Architectural Review Board Staff Report

Meeting Date: December 14, 2023

Location: 1791 Clarkson Road – Clarkson Square Adj. Lot 1

Description: **Clarkson Square Adj. Lot 1:** An Amended Architectural Elevation, Landscape Plan and Architect’s Statement of Design for a retail building, zoned “C-8” Planned Commercial located on the northwest corner of Baxter Road and Clarkson Road.

Figure 2: Colored Site Plan

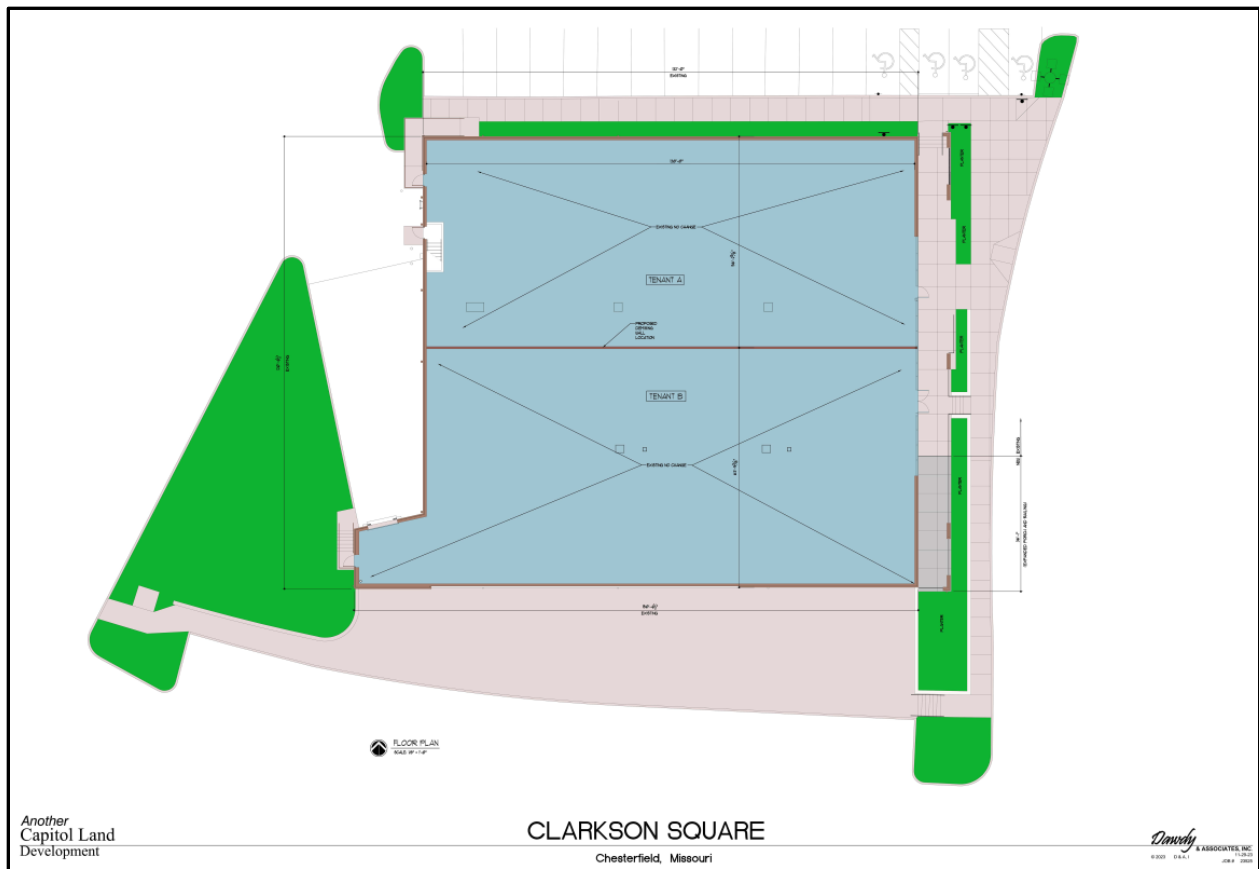
The project was reviewed by ARB on November 9, 2023 and the main points of concern raised by the Board were the massing of the sign band and the overall cohesiveness of the standalone structure with the rest of the strip mall. The applicant has addressed the Boards concerns by reducing the massing of the sign band to expose more of the original architecture of the building. The applicant has ensured that the massing of the sign band was necessary for customer visibility and critical to the overall success of the new retail tenants. The applicant has provided a new colored site plan (Figure 2) and revised colored elevations (Figures 3, 4, and 5).
